Modification Recommended Service Note

34908A Single-Ended Multiplexer Module for 34970A/72A, 40-Channel

Serial Numbers: MY57000865 to MY57499999

The Problem – Hard or too tight to insert the module into 34970A/34972A

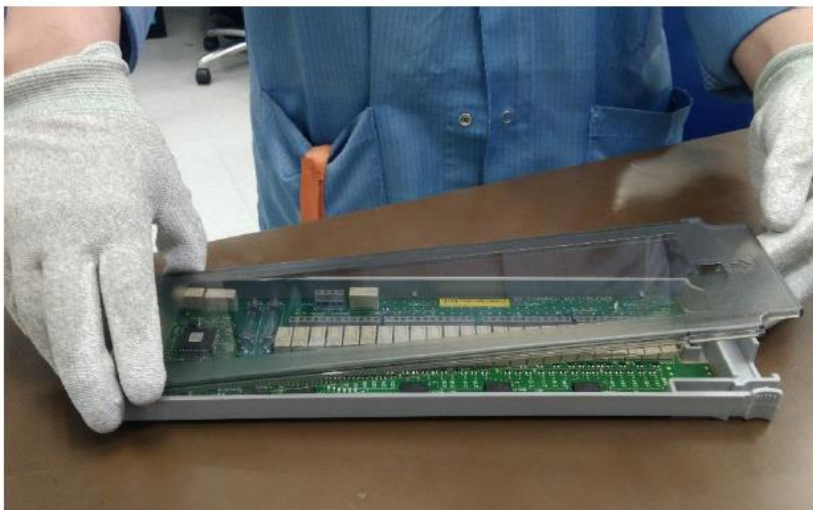
34908A module within the serial number may experience hard or too tight to insert into 34970A/34972A main frame. The top cover width and thickness dimension were out of specifications.

The module that has difficulty to insert into 34970A/34972A can be enhanced by replacing a new top cover. Users can contact Keysight Service Center to request for the enhance top cover and replace by referring to the following procedure as below:
